GRANDVIEW APARTMENTS SUBDIVISION

Revised for the June 19, 2008 meeting

APPLICATION NUMBER 2 DATE June 19, 2008

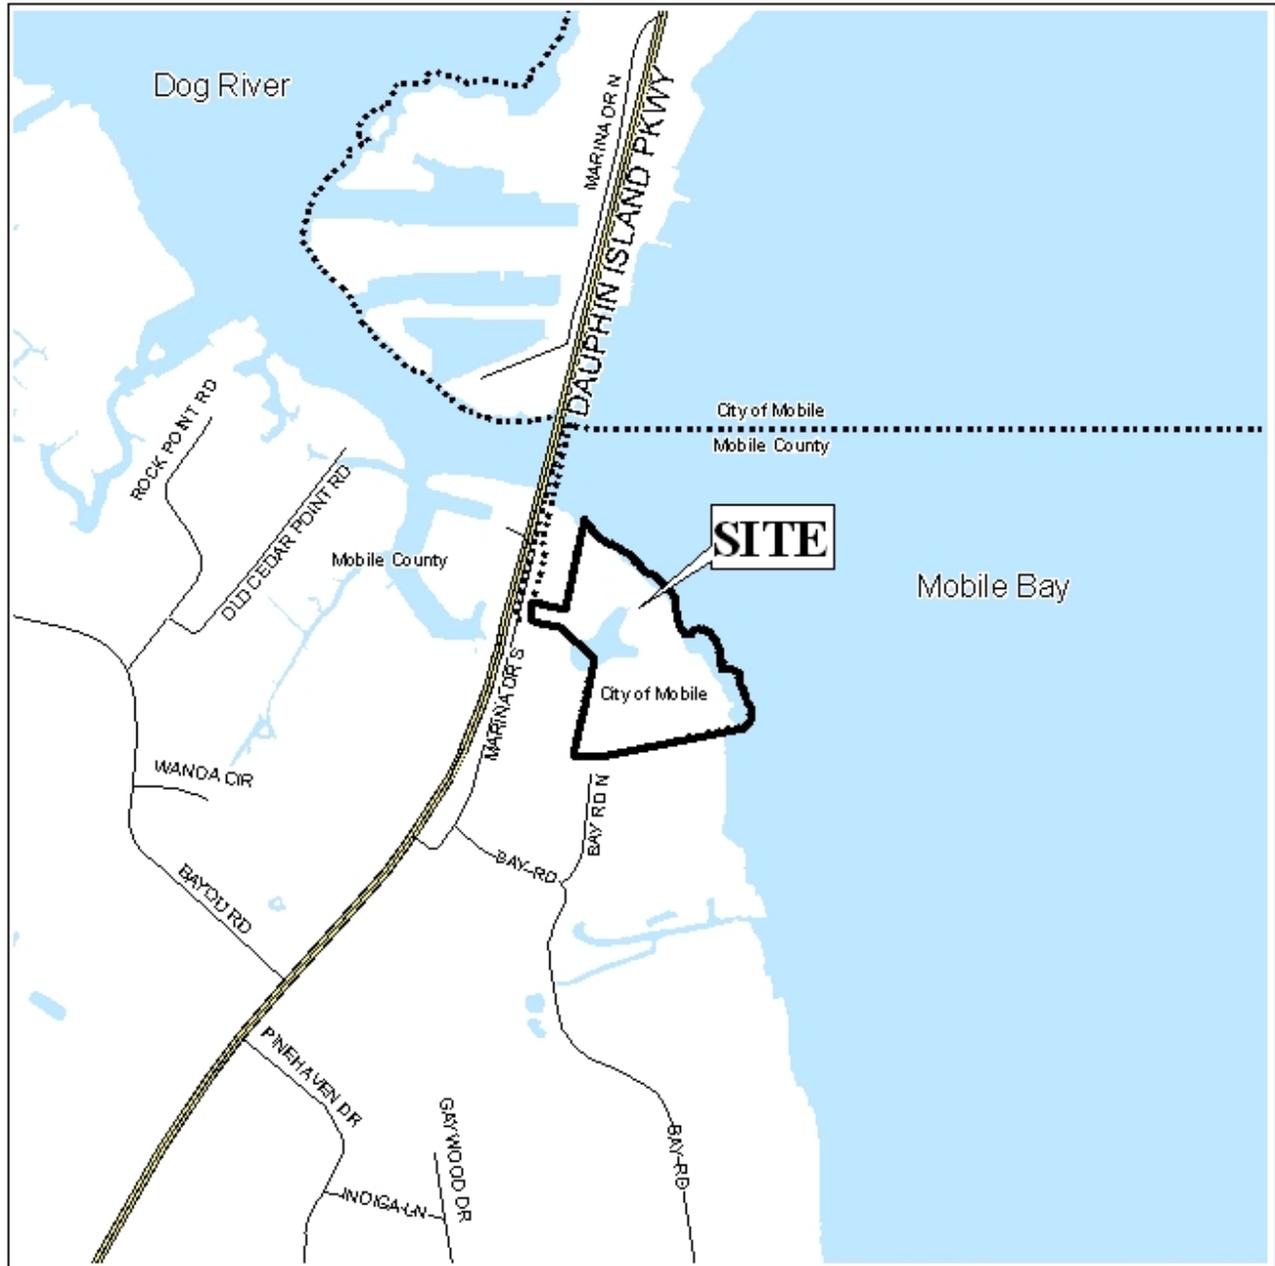
The original development, much of which was damaged/destroyed by Hurricane Katrina, was developed as an apartment complex and was later annexed into the City of Mobile. As such, the site remains zoned R-1, Single-Family Residential. Also, since the site was developed prior to being annexed into the city, there was no PUD approval. While the plan indicates a driveway to Bay Road N, it appears that the gravel from Bay Road N is not a formal driveway, but simply extends gravel within the site to the existing parking lot. In fact, this access to Bay Road appears to be recent in that it did not exist in 2002. City of Mobile aerials from that year clearly illustrate

a dumpster where this “drive” is now located. Further, while not as clear, the 1997 aerials appear to show the same dumpster location.
